WESTAMPTON TOWNSHIP LAND DEVELOPMENT BOARD

MARCH 3, 2021 REGULAR MEETING 7:00 P.M.

**Re: Robert C. Fecso – DR Horton NJ/PA
Preliminary and Final Major Site Plan and Subdivision
Engineering Review #1
Block 204, Lot 2
Springside Road
Zone: R-9 (Residential)
Westampton Township, Burlington County, NJ
CME File: CWAL0204.01**

LAND DEVELOPMENT BOARD REVIEW

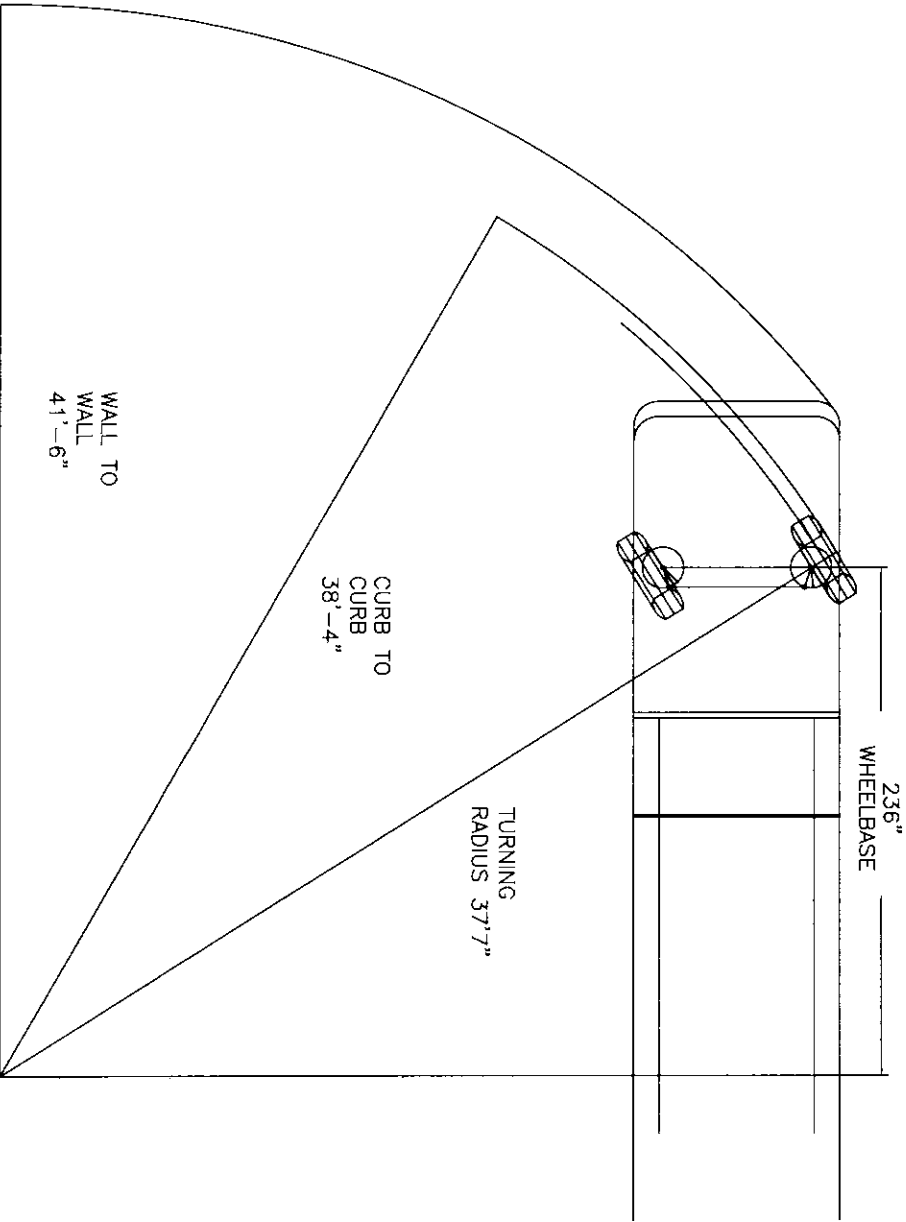
HYDRANTS: - 400 feet or less between each hydrant
- Installed and operational before construction begins.

FIRE PROTECTION SYSTEMS: - R13 System to include attics in all Apartments/Townhouses
- Double 7/8" type x-gypsum
- Vertical fire wall 30" above roofline on Townhouses
